Hume Battery Energy Storage System Project

Response to Submissions Report

IA215400_RTS | Final

Meridian Energy Australia

Figure 5-1 Access for bushfire protection

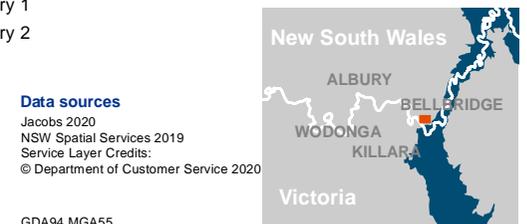
- That a draft Fire Management Plan must be prepared and sent to RFS district office for comment
- All land within BESS site and access roads must be managed as an asset protection zone
- Asset protection zone must include a 10 m trafficable defendable space around all assets, around BESS site and around all areas of unmanaged vegetation to be retained within the site
- All proposed access within the site must be designed and constructed pursuant to Appendix 3 of 'Planning for Bush Fire Protection 2019'.
- A minimum 20,000-litre water supply (tank) fitted with a 65mm Storz fitting must be located adjoining the internal access road within the required asset protection zone.

These options have been provided to RFS for comment with agreed measures to be included in the fire management plan to be prepared in consultation with RFS as a condition of approval.
